UNITED STATES PATENT AND TRADEMARK OFFICE

10/599,900

Office Action Summary	Application No. 10/599,900	Applicant(s) BETTO ET AL.	
	Examiner ANDRES GALLEG0	Art Unit 3637

Haag et al. (US 2514631) - Figures 1 and 3

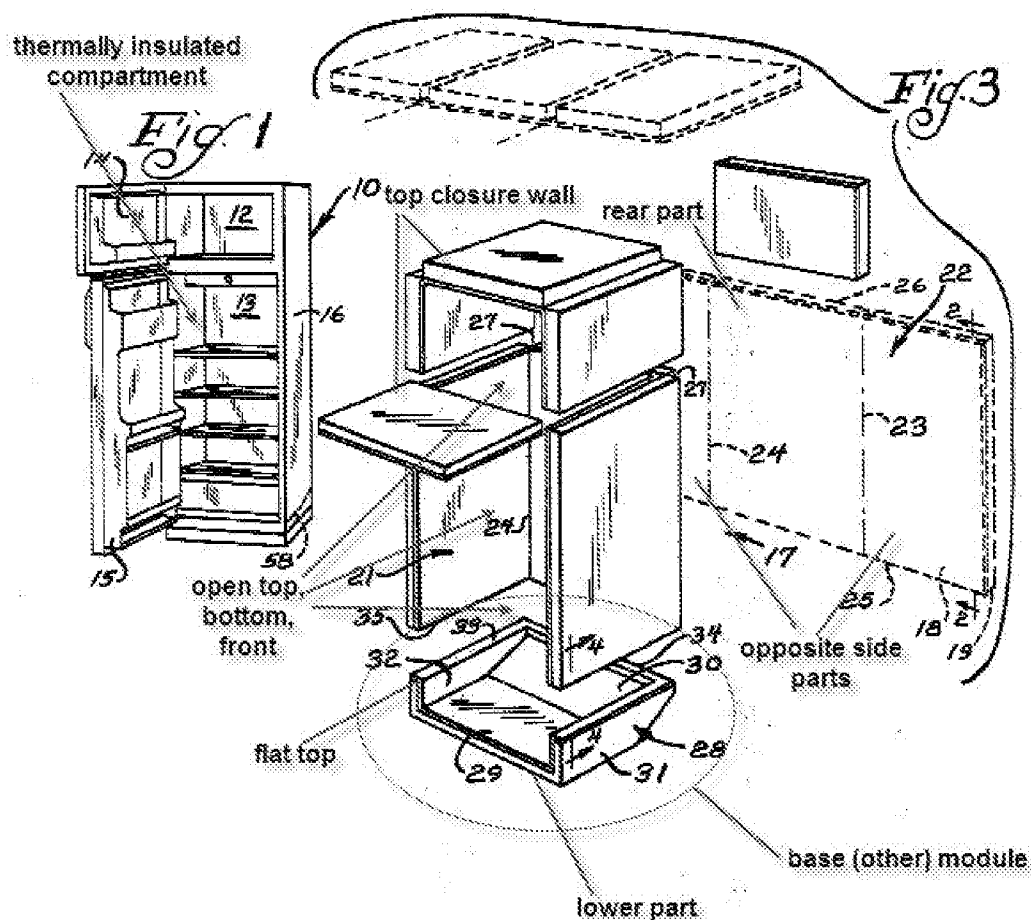
Regarding claim 19, Haag discloses a modular refrigeration and freezer appliance (10) comprising a U-shaped module (21) having a rear part (see annotated Figure 3) connected to a pair of opposing side parts (see annotated Figure 3) and an open top, bottom, and front (see annotated Figure 3); a top closure wall (see annotated Figure 3) closing the top open of the U-shaped module (Figure 3); a bottom closure wall (29) closing the open bottom of the U-shaped module; a door (15) adapted to selectively close the open front of the U-shaped module, wherein the U-shaped module, the top closure wall, the bottom closure wall, and the door define a thermally insulated compartment (see annotated Figure 1); a reversible connector (49) between the U-shaped module and at least one other module (see annotated Figure 3).

Regarding claim 24, Haag discloses the appliance (10) wherein the at least one other module comprises the bottom closure wall (29), or a base module (28).

Regarding claim 25, Haag discloses the appliance (10) wherein the at least one other module comprises the base (28) having a lower part (see annotated Figure 3) and a pair of parallel lateral walls (31, 32) extending perpendicularly from the lower part and having a flat top (see annotated Figure 3) with a portion of the reversible connector (49) (Figure 3).

Elvers (US 2514631) - Figure 1

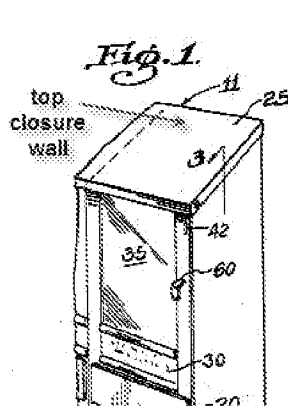
Elvers teaches top closure wall (see annotated Figure 1) comprising a U-shaped profile bar (19) as shown in Figure 2. It would have been obvious to one having ordinary skill in the art at the time the invention was made to modify the top closure wall of Haag, modified by Irmer, by mounting a U-shaped profile bar between the U-shaped module and the top closure wall as taught by Elvers, since such a modification would provide a more secure connection between the U-shaped module and the top closure wall.

Smith (US 3038769) - Figure 3

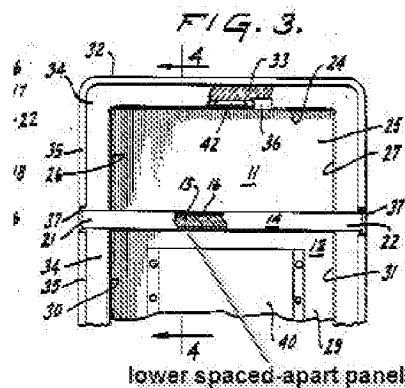
Smith teaches a top closure wall (14) comprising two spaced-apart panels (16, see annotated Figure 3) as shown in Figures 1-5, which when combined with the U-

shaped profile bar of Elvers, the panels define a compartment containing insulating material (15). It would have been obvious to one having ordinary skill in the art at the time the invention was made to modify the top closure wall of Haag, modified by Irmer and Elvers, by mounting two spaced apart panels with insulation as taught by Smith, since such a modification would help keep the compartment to the U-shaped module better insulated.
